**ANGEL PLACE
LEVEL 8, 123 PITT STREET
SYDNEY NSW 2000**

2 September 2022

RESPONSE TO REQUEST FOR INFORMATION - INTERCONTINENTAL HOTEL ALTERATIONS AND ADDITIONS MODIFICATION 2 (SSD 7693 MOD 2)

Figure 1 – Comparison of lift connection location from the function area to Intercontinental Hotel

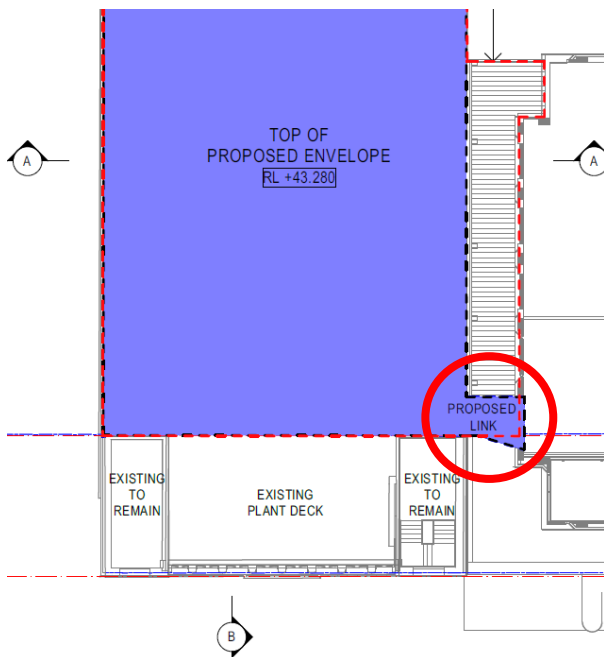
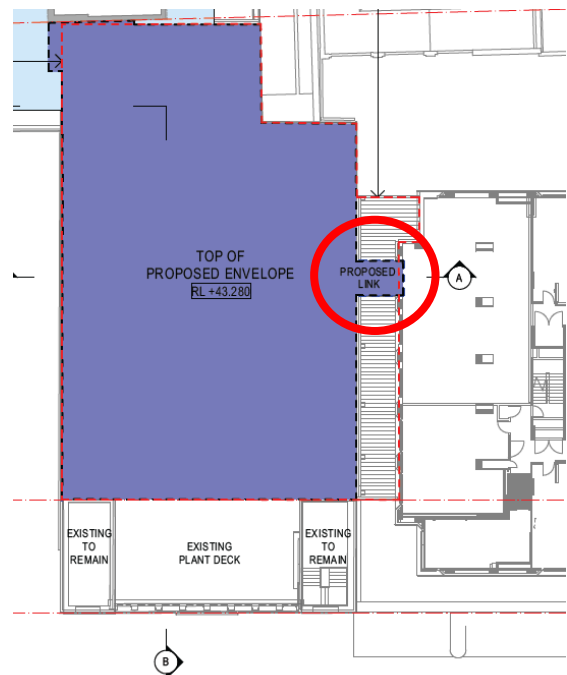
During design development, Mulpha identified an alternative location for the proposed lift/link connection. The location of the proposed (new) lift/link connection is shown in the figure below and circled in red.

The amended envelope seeks a very minor non-compliance with the approved setback to enable space for the proposed lift/link connection to/from the Intercontinental Hotel. Mulpha found the new lift/link location provides a more logical connection point to/from the Intercontinental Hotel.

Figure 2 – View Study Analysis of the new lift connection location

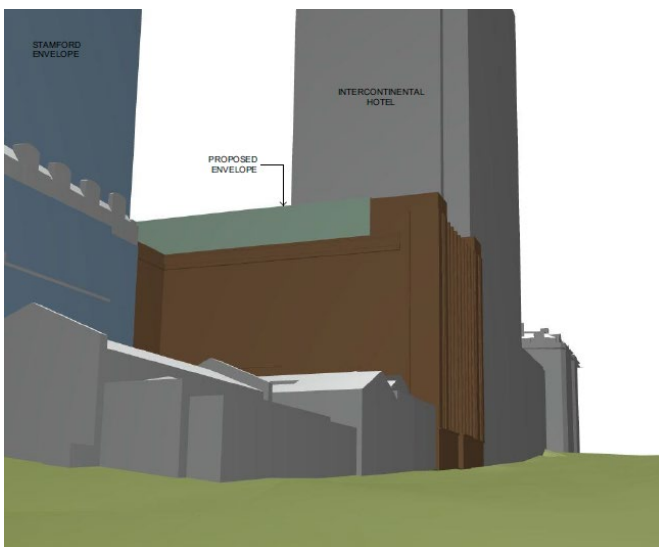
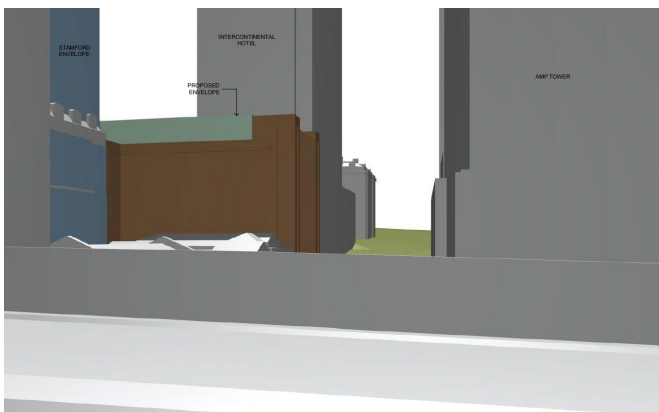
Cottee Parker have prepared a view study of the proposed Phillip Street elevation from key vantage points (Appendix A). The view study demonstrates that from key vantage points, the proposed lift connection is shielded by the existing plant deck area. Refer to the figures below.

The minor lift connection will not be visible from key vantage points and will not create any negative heritage or visual impacts. Therefore, the initial reasons for approval remain valid and this minor modification will not have any consequential environmental impacts.
